SERVICE BULLETIN

SUBJECT	DATE
TR-2600A PLL UNLOCK (TROUBLESHOOTING)	10-18-85

TR-2600A PLL UNLOCK

1-14-86

On the TX Unit (X56-1470-10)

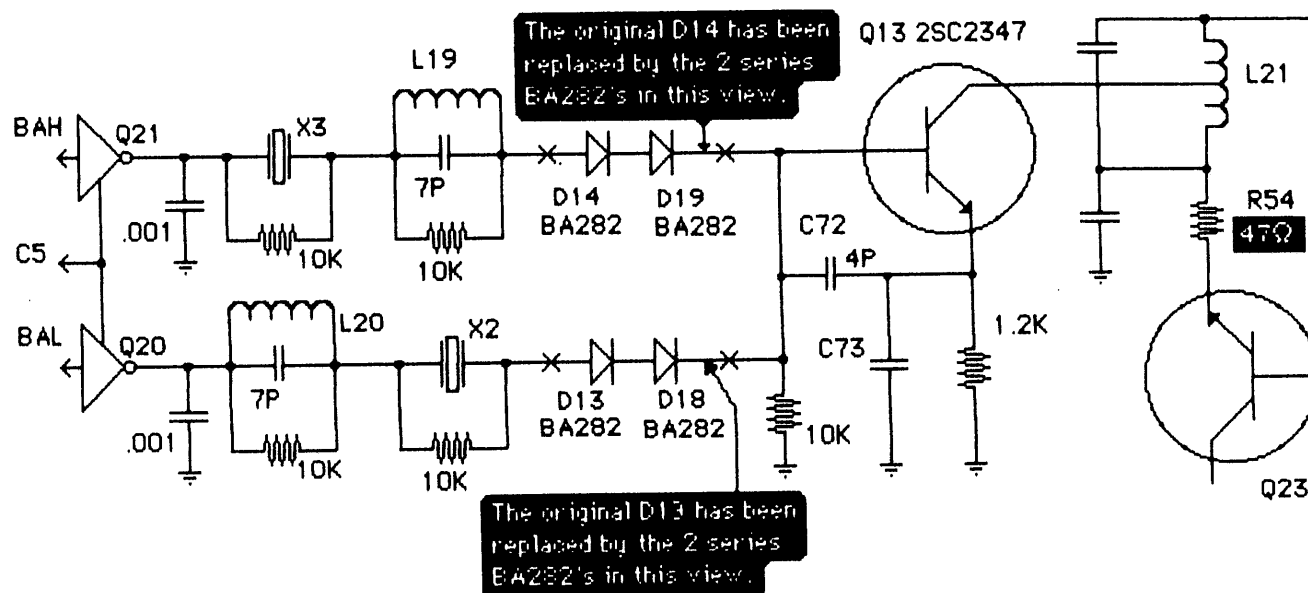
Some cases of PLL unlock on the TR-2600A may be caused by a failure of the crystal oscillator circuit X2,X3, and Q13. This may be corrected by performing the following changes.

Replace Diodes D13, and D14 (MA856) with a series pair of BA282's as shown in the diagram below. Also change resistor R54 to 47Ω as shown.

Parts required:

BA-282 diode.....4 each.

47 Ω Chip resistor (RD73FB2A470J).....1 each.

This change is applicable to serial numbers before SN 702XXXX.
